VILLAGE OF WAUNAKEE/TOWN OF WESTPORT JOINT PLAN COMMISSION 5387 MARY LAKE RD, WESTPORT July 12, 2016 - 6:00 PM

AGENDA ITEM: DISCUSSION / ACTION ON CSM LOT 266 KILKENNY FARMS, RELATED TO THE AT HOME AGAIN SITE PLAN

AGENDA ITEM: DISCUSSION / ACTION ON AT HOME AGAIN SITE PLAN/SIP, LOT 266 KILKENNY FARMS

Re: At Home Again Site Plan

CERTIFIED SURVEY MAP

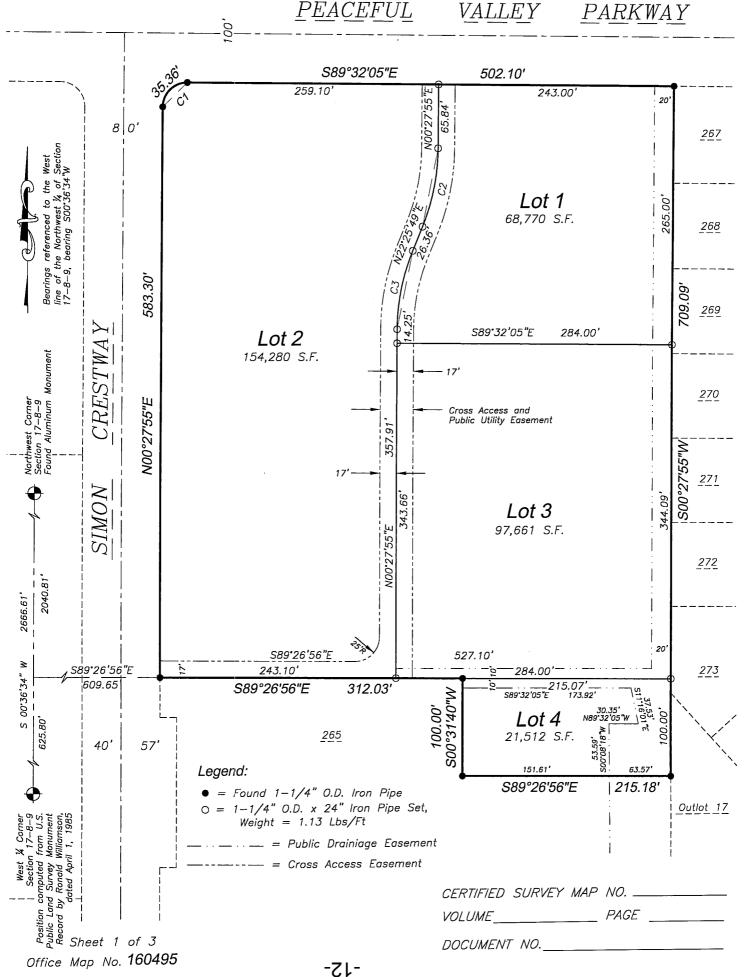
The CSM splits Lot 266 in to four lots. Three are larger, but Lot 4 is smaller than 1/2 acre. There also appears to be a sizable drainage easement area designated on Lot 4, possibly making the lot too small to support commercial or office use. Perhaps the applicant can comment on its intentions for this small lot.

There are also a few minor technical issues to address. First, the description of the West 1/4 Corner of Section 17 tie should be made the same as that shown on the Plat of Kilkenny Farms. Next, there is a typographical error in the legend to correct. Finally, the applicant should check the bearing on the new easement along the north line of Lot 4. Should it be S 89-26-56 E?

Sewer and water service to the original Lot 266 was to be from Simon Crestway main. Because of the division of this lot into three viable lots, service to the proposed Lots 1 and 3 of this subdivision are proposed to be from new sewer and water mains to be installed in a cross access and public utility easement. We agree that these 8-inch mains are necessary for proper service to the two lots. The easement is also intended to provide vehicle access to the lots, with a 29 foot roadway constructed over the top of the mains. This should give proper access to those public facilities for cleaning and maintenance. We request that the plan callout the station/offset of the water main bend near station 36+25.

1. The proposed water main that runs east to west to serve the newly divided lots is not within the proposed utility easement. A separate easement should be granted across Lot 265 to contain the proposed water main. This main is also not shown in the profile view of the drawings provided to us. We request that an updated drawing be provided for review.

2. There is considerable off-site construction required to get the sanitary sewer to Lots 1 and 3. The applicant proposes to install these sewers on Lot 265, just east of the Simon Crestway right of way. If they are installed there, an easement will be needed to contain the sewer, and plan/profile drawings should be provided for review of this off-site work.

At 28 feet wide, the access road is too narrow to allow parking on one or both sides. Thus, it will be very important moving forward that the individual site plans that are proposed have more than enough space for adequate parking on their lots, or a plan for shared parking if peak demands for parking on various lots offset.

AT HOME AGAIN - WAUNAKEE AT HOME AGAIN WAUNAKEE, DANE COUNTY, WI

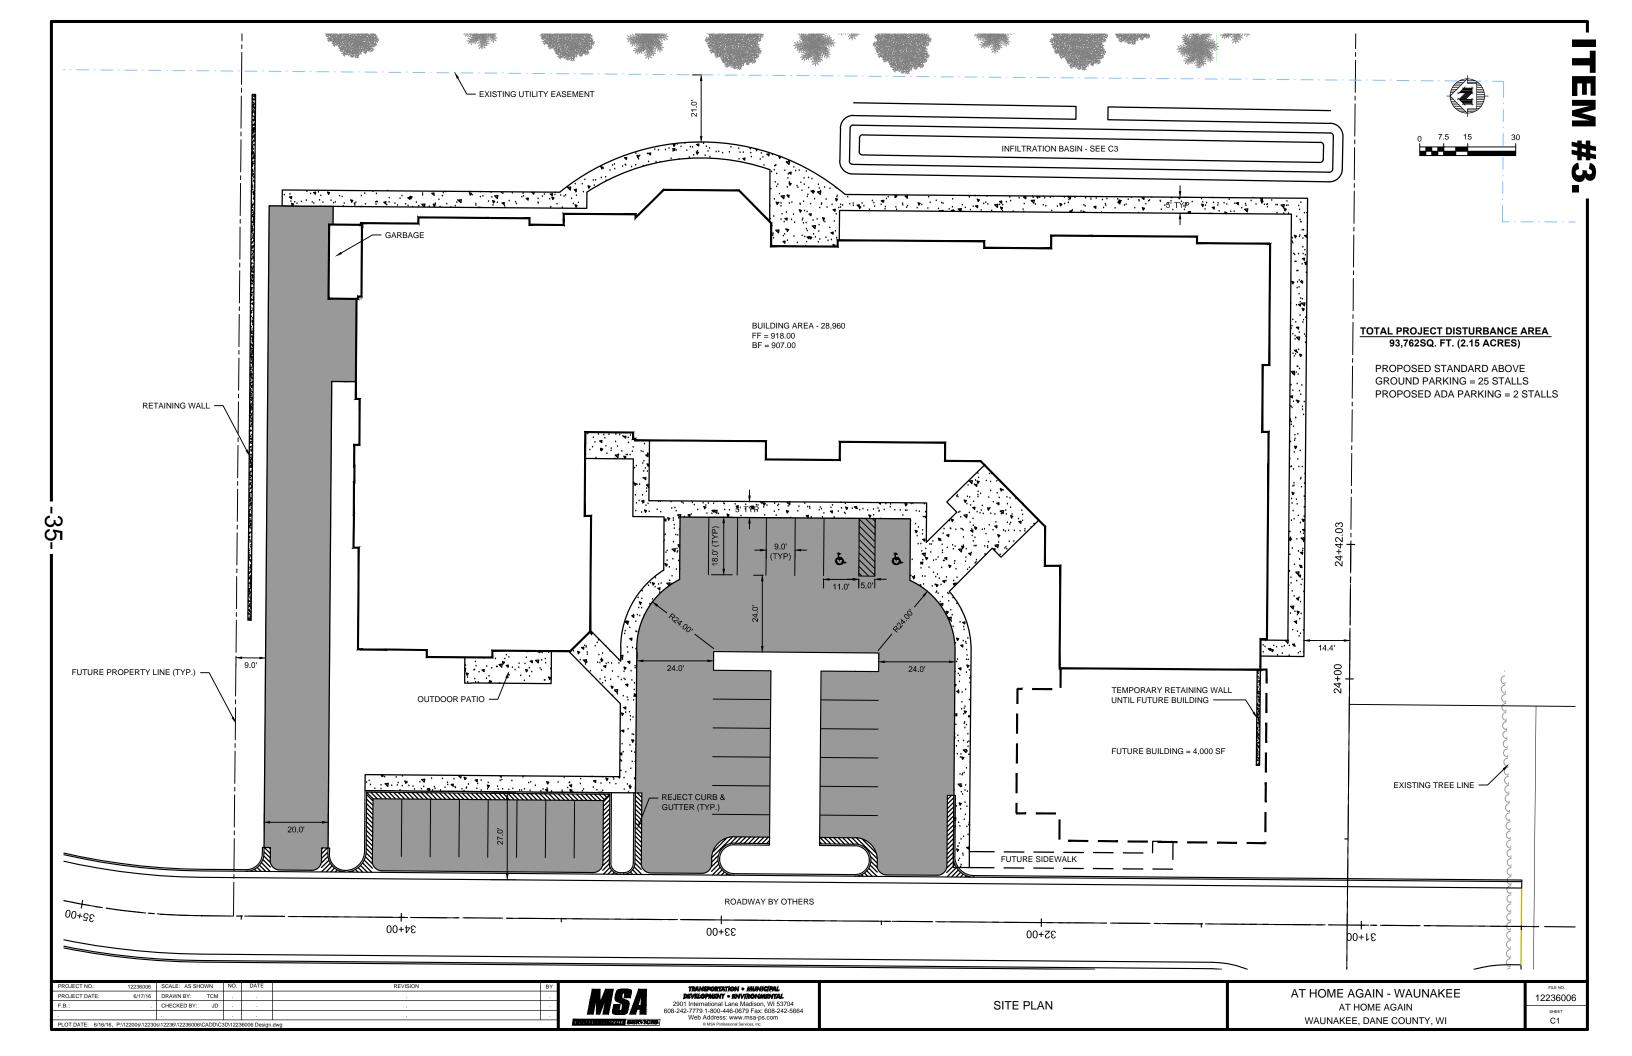
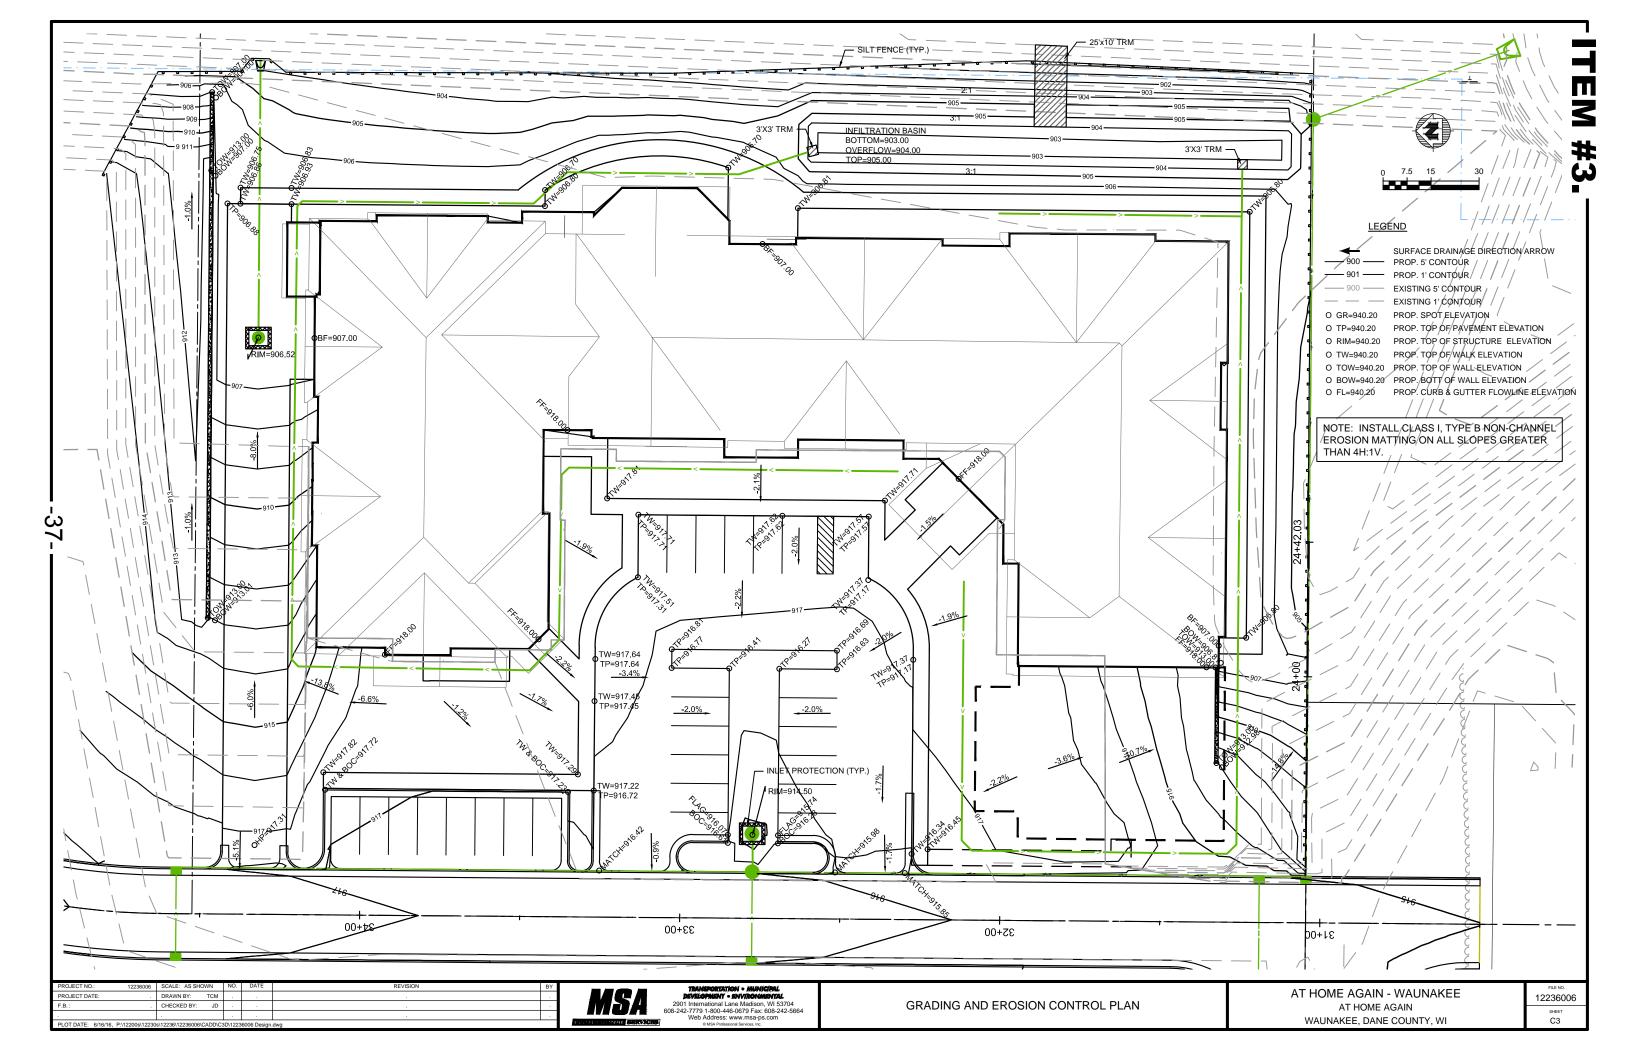
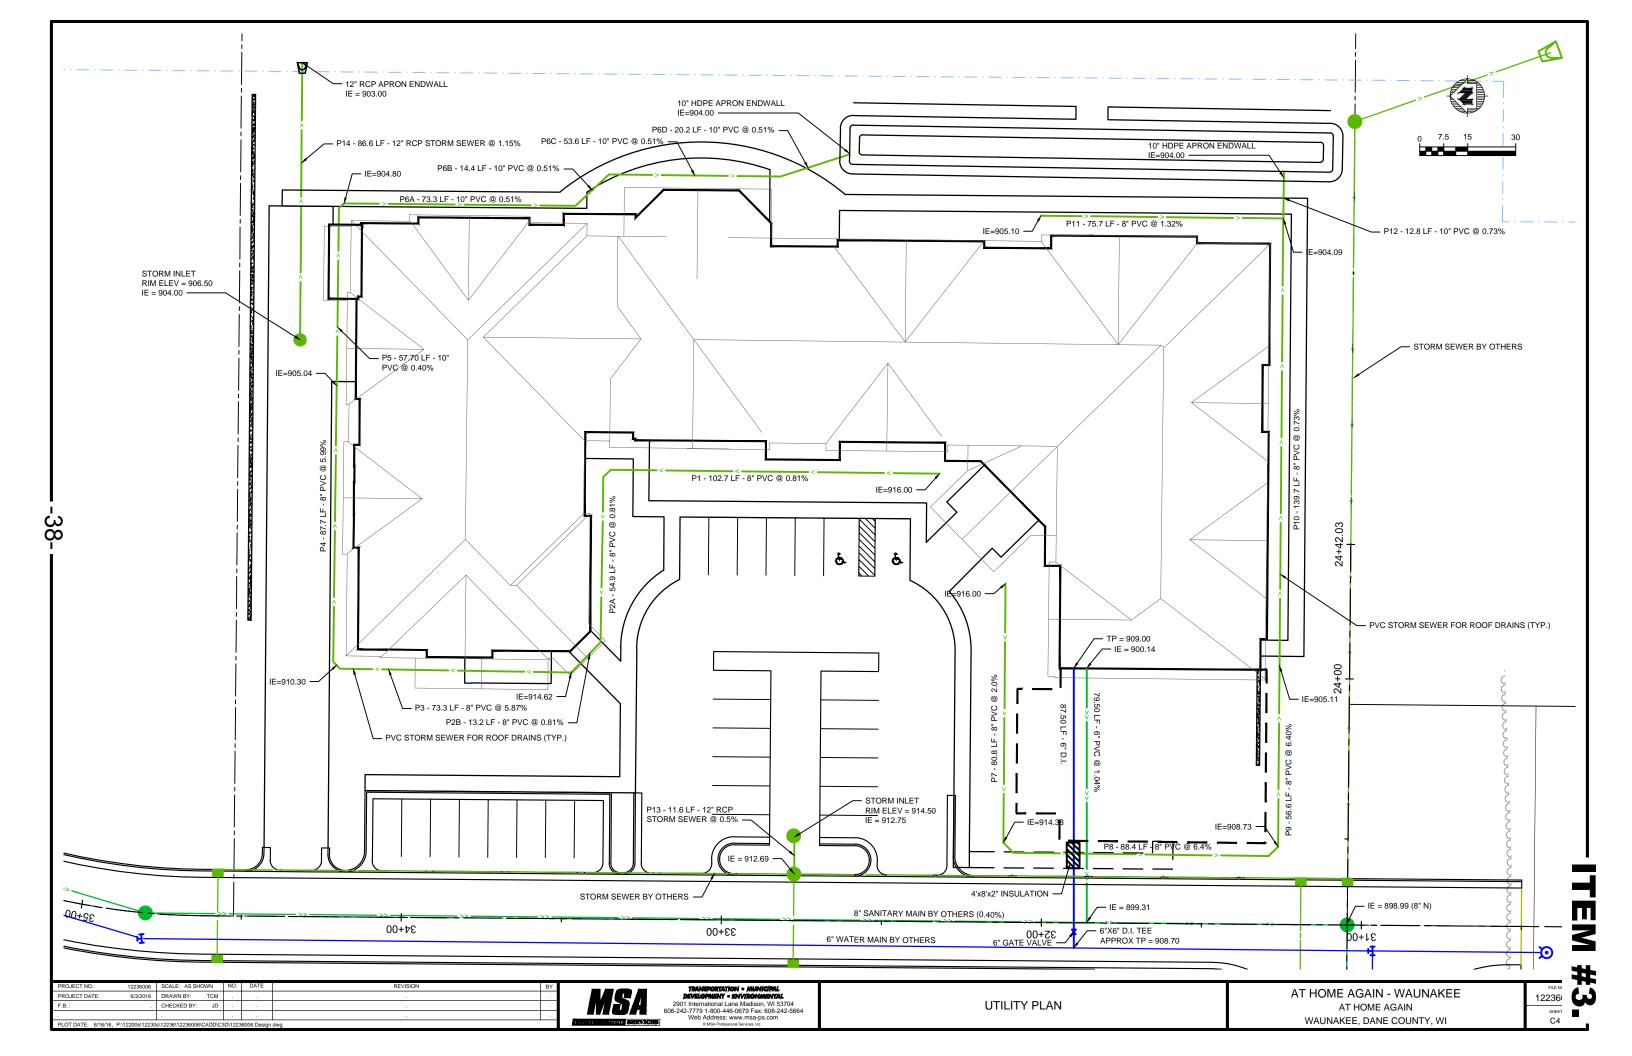
Assisted living is an acceptable use on Lot 266, according to the General Development Plan for the plat. Building setback requirements for this lot appear to be 15 feet to the front, rear and side lot line. The plan appears to meet these requirements, however, the improvements are densely placed on the site, which impacts design of some site features. A roadway is planned to access this building, and presumably future buildings in the area. We presume this roadway is intended to be a private road. An easement is provided to contain the public sewer and water utilities.

The plan provides 27 surface parking stalls, and 24 underground parking stalls, for a total of 51. All would be constructed in the first phase of construction. The first phase of construction is indicated to have 52 assisted living units. The village ordinances require between 1 and 1.2 stall per bed, depending on which use you consider, so this would indicate the parking for the first phase of development would be basically met. Once the additional 18 assisted living units in Phase 2 are constructed, the parking requirement of the code would be exceeded.

The applicant indicates that the 51 proposed stalls are more than enough for the anticipated staff, residents and visitors at any one time at full build out. Perhaps this is true, but it would be helpful if the applicant provided supporting information, say data from their existing similar facilities, that would show the actual count of the number of cars per resident. This would help establish a basis for a waiver of the ordinance.

Eight stalls are planned adjacent to the access road to be constructed by others. This configuration is not ideal, as vehicles will have to back into traffic. A larger site could allow for incorporation of these stalls into a more acceptable parking layout and circulation pattern.

The roadway serving this site (and other lots created by the subdividing of Lot 265) is proposed to be 28 feet wide from face to face of curb. This is adequate for two way traffic, but dedicated bike lanes would not work here, nor should on street parking be allowed. Also, no sidewalk is shown that would provide continuous access to and across the proposed lot. This seems like a facility that would benefit from a sidewalk connection to Simon Crestway and to Peaceful Valley Parkway. Lastly, if this were to become a public road, the front yard setback of the Phase 2 addition would violate the 15-foot setback requirement.

Lighting for the site seems to be unusually strong. Intensity in the interior exceeds 24 foot-candles, and some intensities at the lot lines are greater than 8 foot-candles. A justification of this light intensity should be provided. Ordinances allow for up to 3 foot-candle intensity at any lot line, so some adjustments should be made. The lighting plan should be very sensitive to the adjacent residential lands to the east, and provide evidence that cutoff shades for the fixtures which direct light downward to the ground surface are being provided. Finally, the light poles on the north and west sides of the property appear to be placed off the property, so that should be addressed.

There are two retaining walls on the site, with heights up to 6 feet. These walls will require protective railings, and should be shown on the plan.

There were no sign plans provided, so separate review of those will be required. Space for a ground sign near the access road is very limited due to the proposed future expansion, driveways and parking areas, and a stormwater management area.

There was no landscaping plan provided. This is a required part of their site plan submittal.

Sewer and water utilities will serve the site from the proposed access road. The services appear reasonable. We will provide comments on the sewer and water mains to be extended to the site in a separate letter, regarding Lot 266 Certified Survey Map.

Regional stormwater ponds will provide the stormwater quantity and quality measures required for this site. Storm sewer collection basins and piping appear to effectively collect and route the runoff from this site to these regional basins. The applicant should provide a stormwater management report to confirm the adequacy of the infiltration basin shown on the site. For efficiency of review, we will wait on our review of that facility until we are provided the report.
